P802.1AS-2025-Rev: syncGrandMasterIdentity and syncStepsRemoved propagation

Alon Regev [Keysight]

- 802.1AS-2025-Rev-D0.2 comment 50:
with Drift_Tracking TLV usage, the global variables syncGrandMasterIdentity and syncStepsRemoved are copied to globals regardless of whether the receiving PTP Port is in TimeReceiver portState so a transmitting port (and internal usage) would randomly get the values from one of the ports that receive Sync / Follow_up messages.
- This slide set discusses the issues and options to address
- Underlying documents:
 - [AS]: 802.1AS-2025
 - [ASRev]: P802.1AS-2025 Rev/D0.2

Part of Figure 10-2

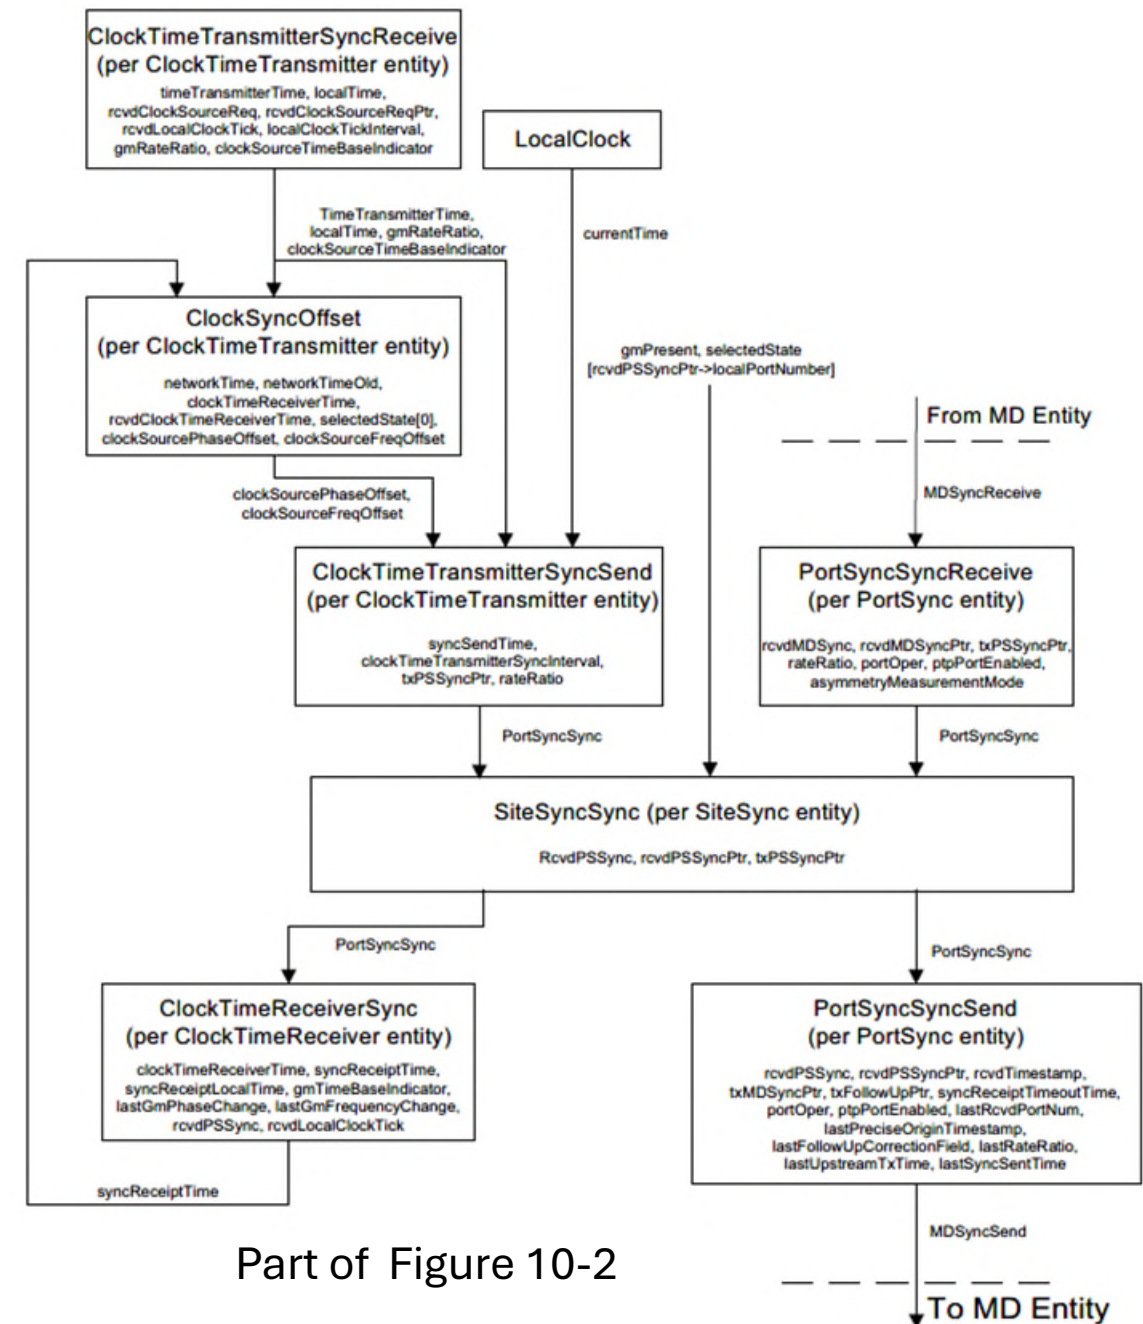
- Only the SiteSyncSync state machine is acting on the basis of Port State
 - It checks if $(\text{selectedState}[\text{rcvdPSSyncPtrSSS} \rightarrow \text{localPortNumber}] == \text{TimeReceiverPort})$ as a qualifier to entering the RECEIVING_SYNC state and forwarding data from the incoming PortSyncSyncSync structure to all the PortSyncSyncSend and ClockTimeRecieveSync SMs.
- The PortSyncSyncReceive and related MDSyncReceiveSM do not take Port State into account
 - Data from all incoming Sync messages is processed and forwarded towards the SiteSyncSync SM

Drift tracking implementation

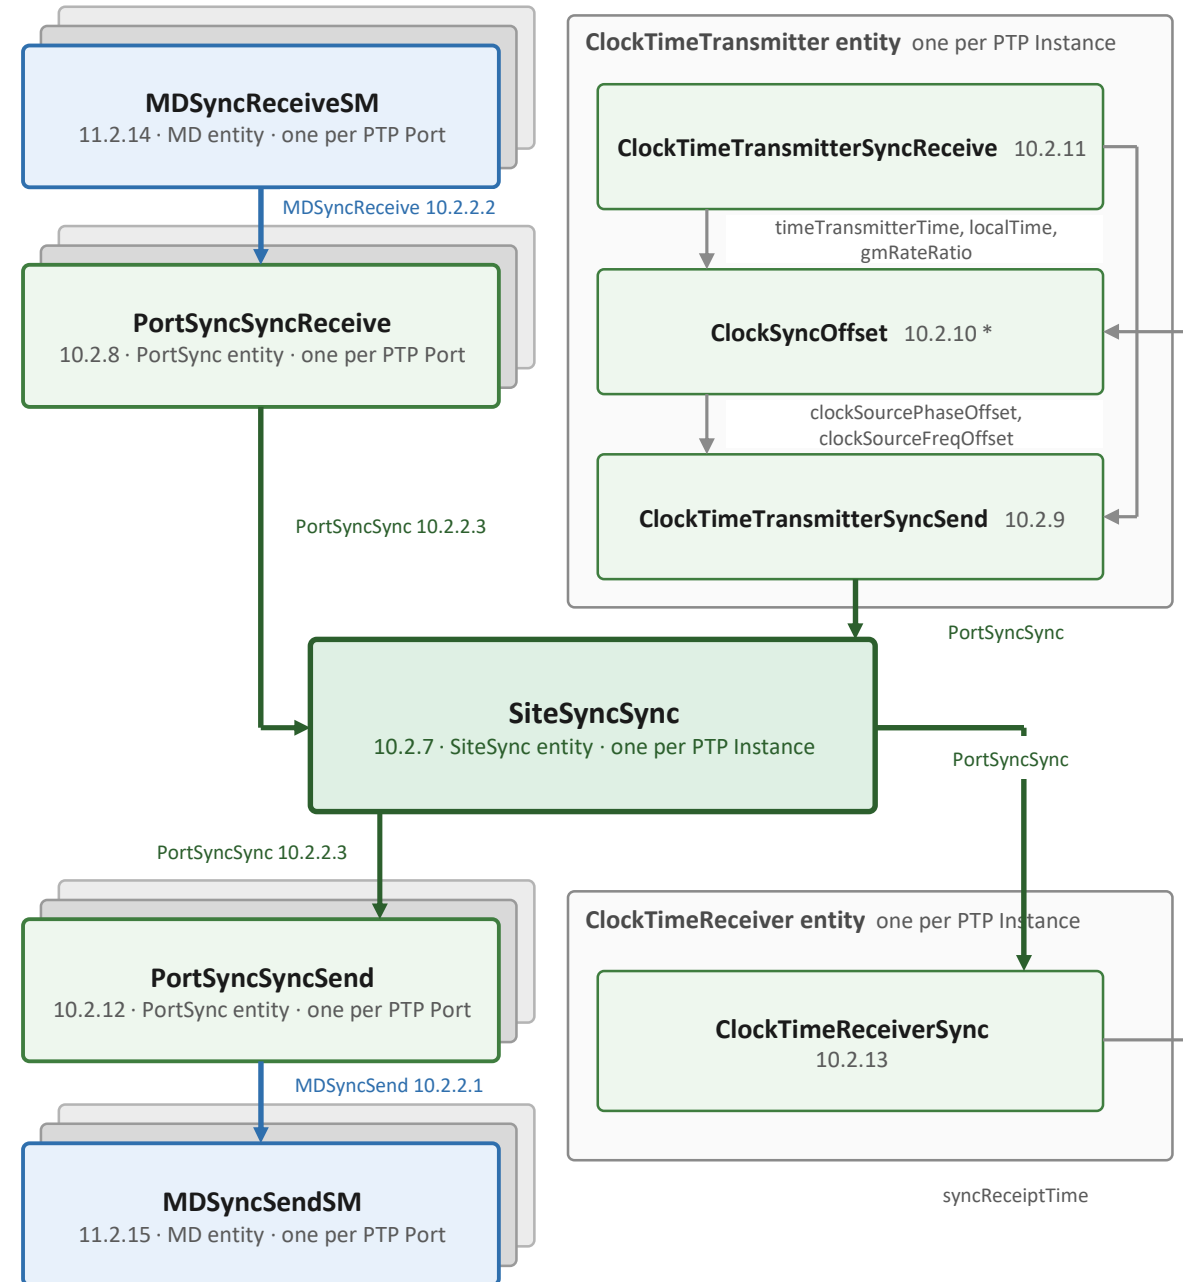
- 2) syncStepsRemoved is set equal to the value of the global variable syncStepsRemoved (see 10.2.4.27).
- The MDSyncReceiveSM does not take Port state into effect, so a Sync message received on any port (not only the TimeReceiver port) will update the globals.

- The value sent by the MDSyncSendSM could contain a combination of Sync data received on one port (the TimeReceiver port) and globals set from Drift_Tracking TLV received on a different port (such as a Passive or Disabled port)

Possible solution 1: MDSyncReceiveSM to check Port State prior to assigning data to globals

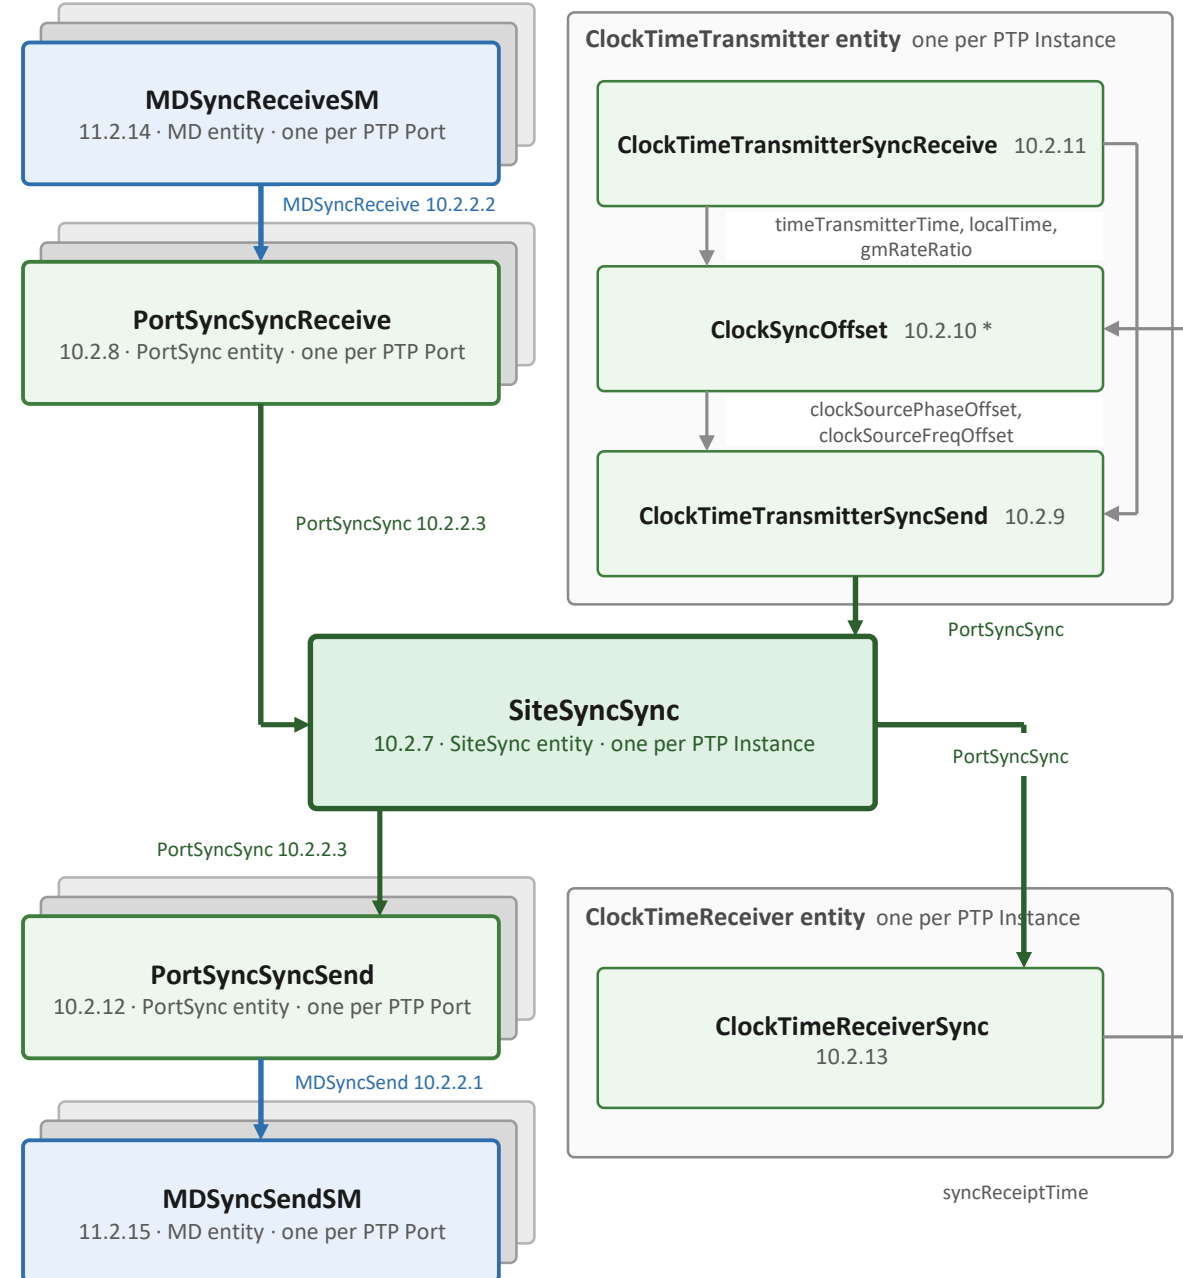
- Modify 11.2.13.2.1 f) and g), add “If the Port State of the PTP Port is TimeReceiver”
- Pros
 - Likely simplest solution
- Cons
 - Potential race condition when clock source changes
 - Inconsistent with structure of the rest of the state machines
 - Does not account for drift between the GM clock source and GM local clock
 - Does not allow Drift Tracking support by other MD types

Possible solution 2: Transfer the syncGrandmasterIdentity and syncStepsRemoved to the SiteSyncSync SM and have the SiteSyncSync choose the source

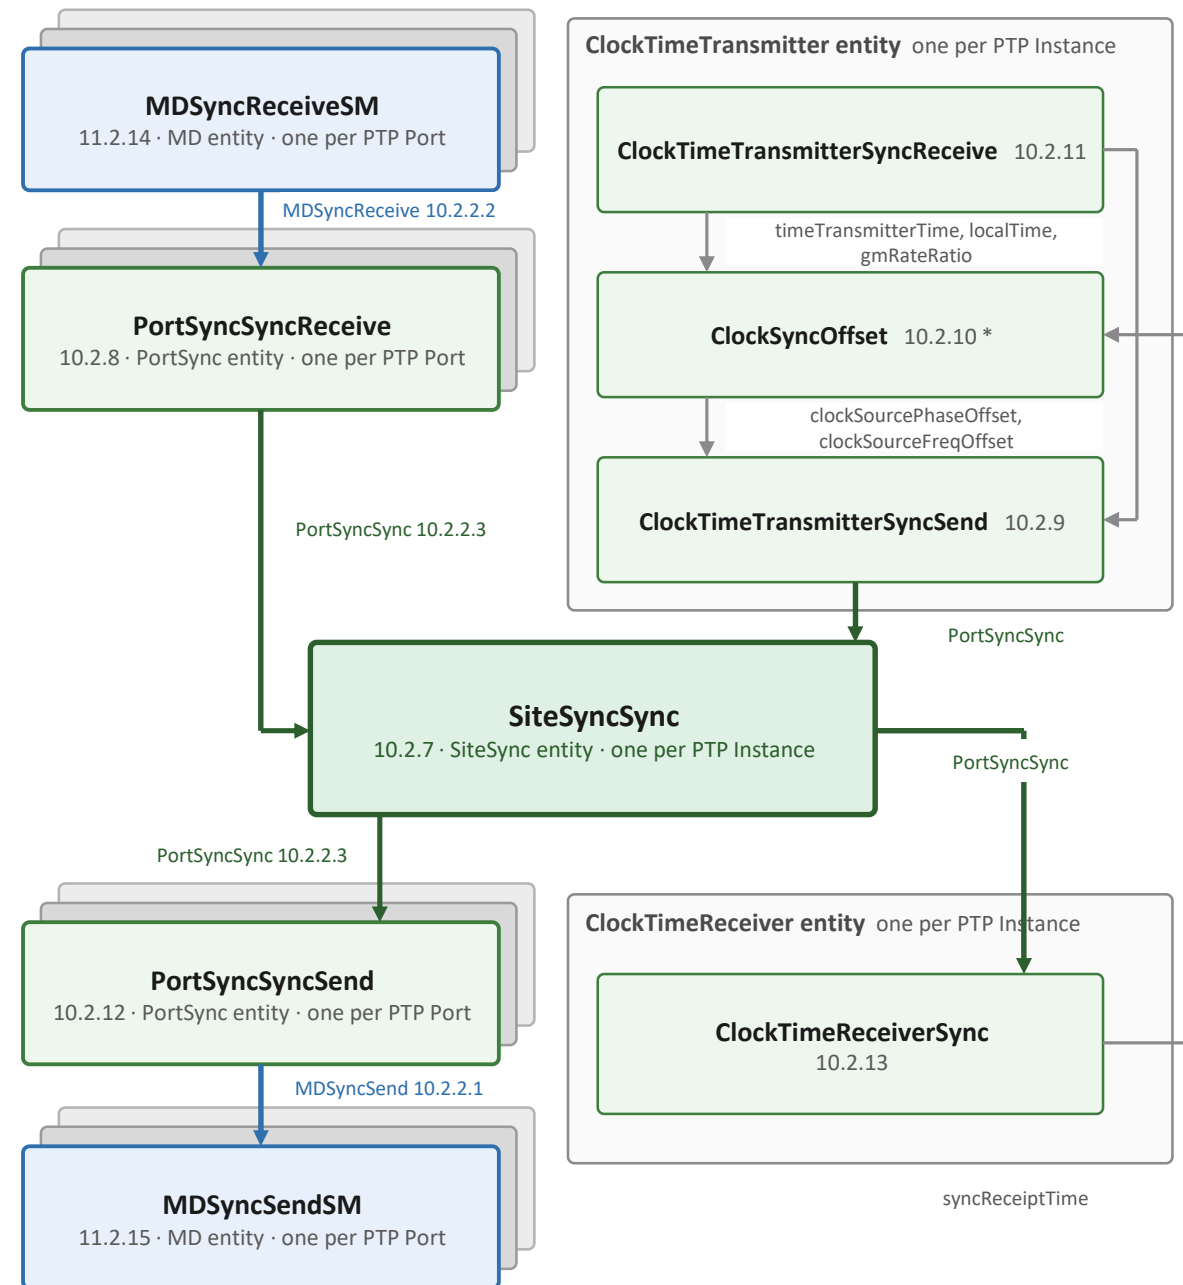
- Modify MDSyncReceive, PortSyncSync, and MDSyncSend structures to add the Drift_Tracking data
- Transfer the data along the path from the MDSyncReceiveSM to the SiteSyncSync
- The SiteSyncSync will transfer the data from the current TimeReceiver
- Pros
 - Consistent with structure of the rest of the state machines
 - Allows adding Drift Tracking support to other MD types and to drift between the GM clock source and GM local clock
- Cons
 - May require touching every MD clause to set Drift Tracking fields in the MDSyncReceive structure to default values.
 - More complicated change
- Pro/Con:
 - Moves Drift Tracking from Clause 11 to Clause 10 (which depends on your opinion may be good or bad)
 - How much of Drift Tracking to move can be discussed
